LRB-2022-42
21/02140/FLL - Alterations and formation of balcony and external stairs, Rognvaldsay, Perth Road, Blairgowrie, PH10 6EJ

21/02140/FLL - Alterations and formation of balcony and external stairs, Rognvaldsay, Perth Road, Blairgowrie, PH10 6EJ

NOTICE OF REVIEW

PROPOSED DEVELOPMENT: ERECTION OF A BALCONY
AND SPIRAL STAIRCASE

PHOTOS

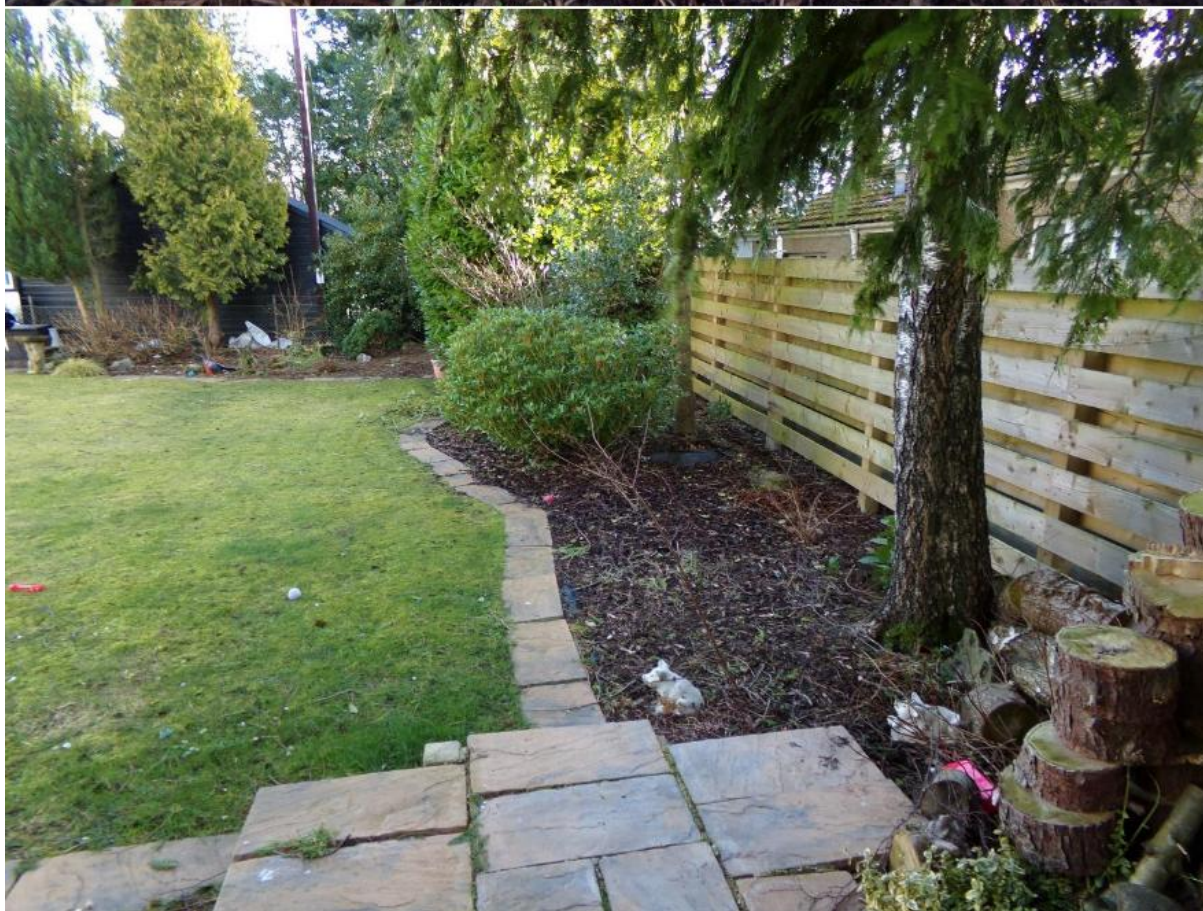
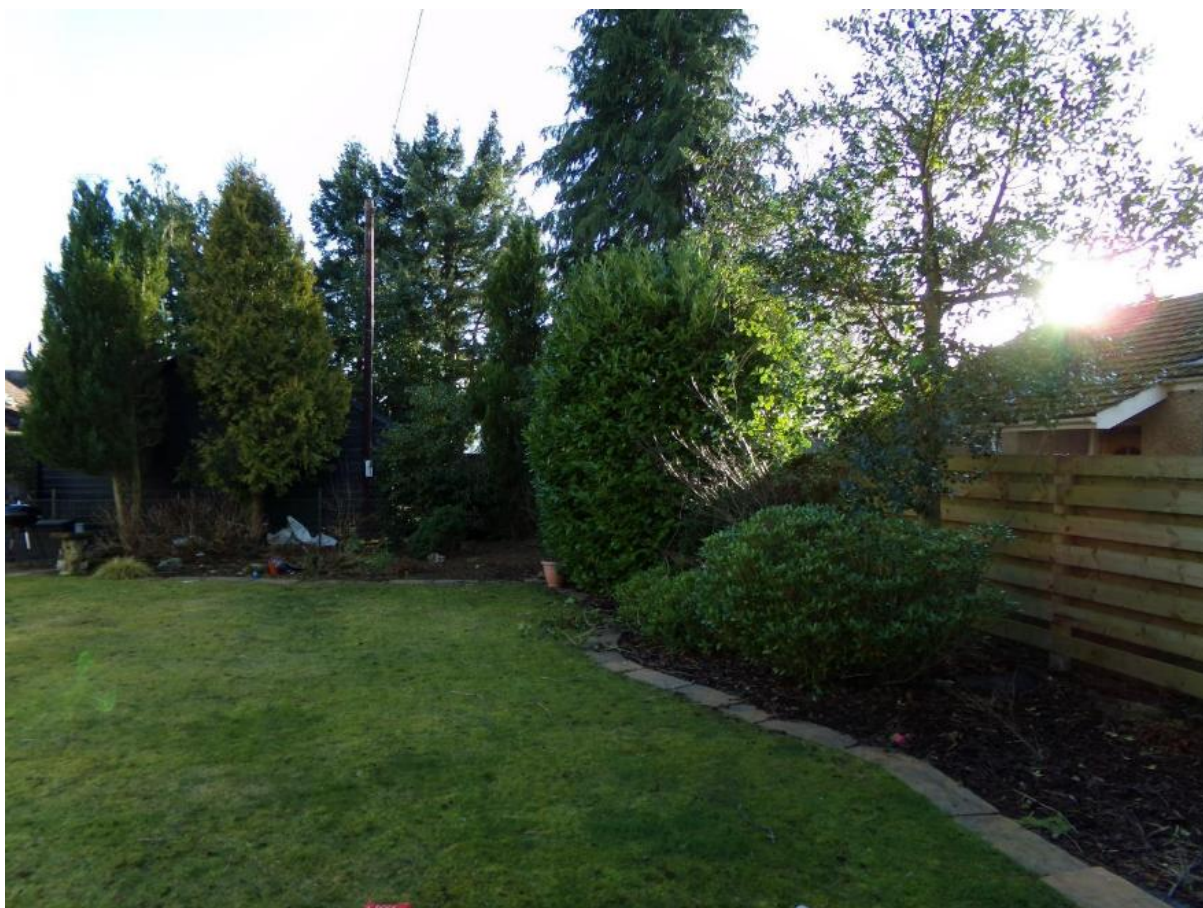
I've attached photos of the Applicant's property as well as photos (5th last photo at normal view and final 4 photos at zoomed in views) of the Objector's property when viewed from the Study. There is a bedroom window, rear external door and a clothes pole visible on the Objector's property. The fence and mature trees on the Applicant's property also provide a significant degree of privacy to the Objector's property.

5.3 The refusal comment 'create direct and uninterrupted lines of sight towards neighbouring properties and their associated areas of private amenity space' is factually incorrect. The photos provided are proof and it's unclear how this statement could be made without a site visit.

PROJECT: PROPOSED ALTERATIONS AT ROGNVALDSAY, PERTH ROAD, BLAIRGOWRIE PH10 6EJ		NORMAN A MACLEOD		DATE: JULY 22
DRAWING REF: BALCONY WITH 9M RADII SIGHTLINES		namacleod@aol.com		SCALE: 1 TO 50
PAPER SIZE: A1		Tel: 07884177328		DRAWING NO: 6
				REVISION:

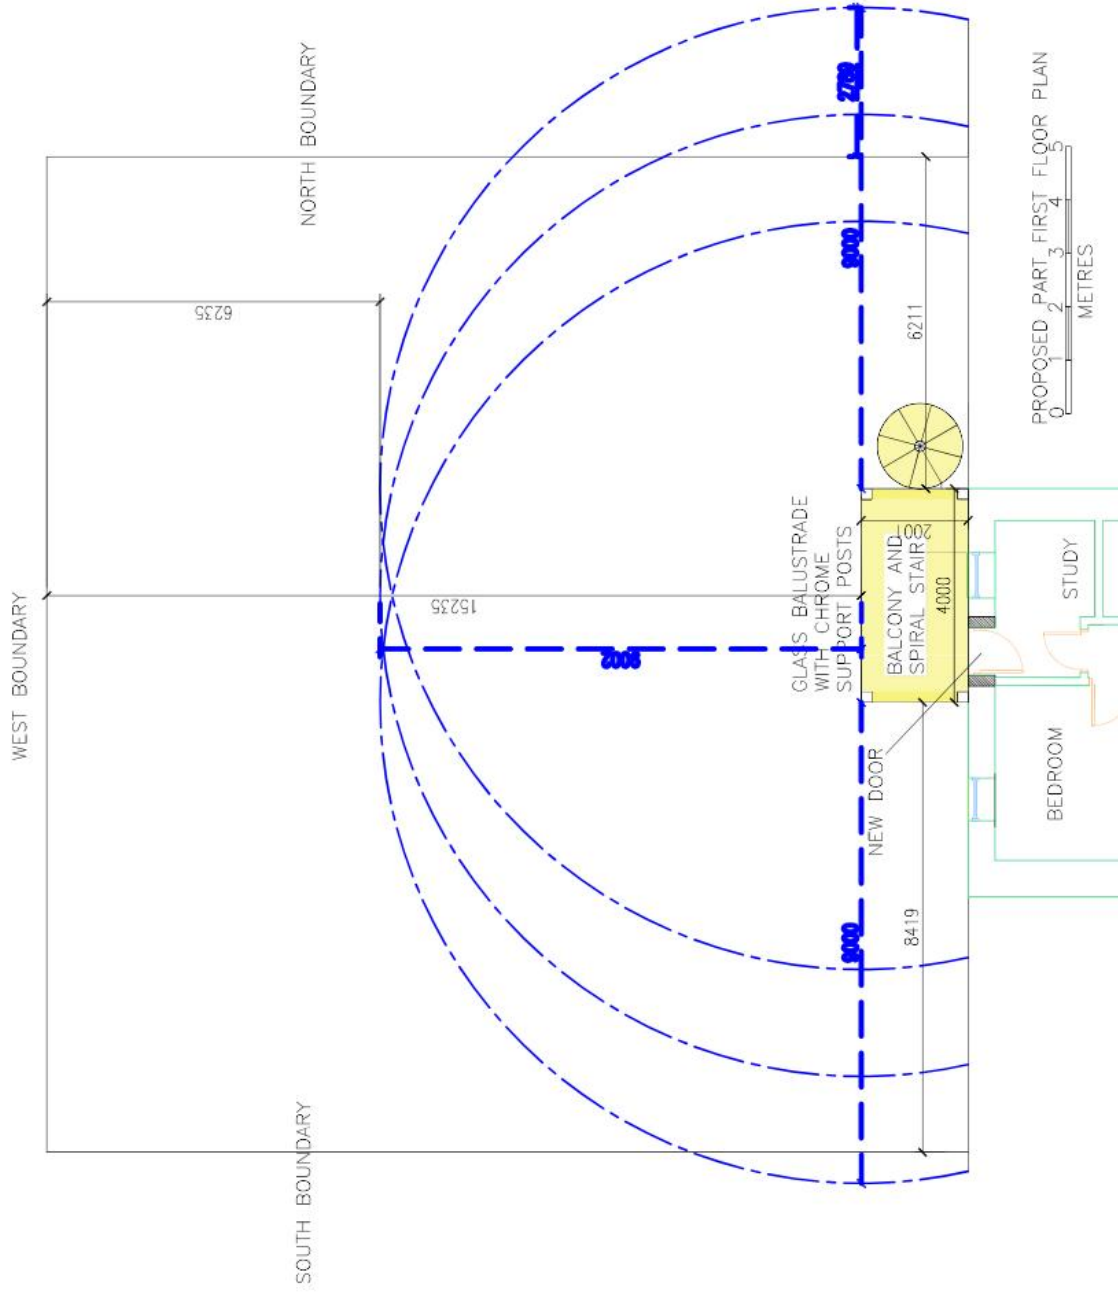
DRAWING No6 ILLUSTRATING 9M RADII FROM THE BALCONY TO THE BOUNDARIES.

I PREPARED THIS DRAWING TO OBTAIN A BETTER UNDERSTANDING OF THE REASONS FOR REFUSAL.

3.2 Please see additional drawing showing the radii of the sightlines in blue. Contrary to the Planning Officer's reasons for refusal the lines of sight are interrupted to the rear by fences, trees and the applicant's garage. This is most evident in the photos that were requested by the Planning Officer but did not visit the site.

3.3 Within the 9m range there is no impingement to the rear West boundary, in fact there is a further 6.235m which is screened by a fence and trees.

3.4 To the South boundary there is an impingement of 600mm maximum which is a footpath adjacent to the boundary fence. The private amenity areas referred to in the Planning Officer's comments is the neighbour's footpath leading to the back garden.

3.5 To the North boundary there is a greater impingement of 2.789m, however, the view is impeded by the applicant's garage. Additionally, a privacy screen could be introduced if requested.
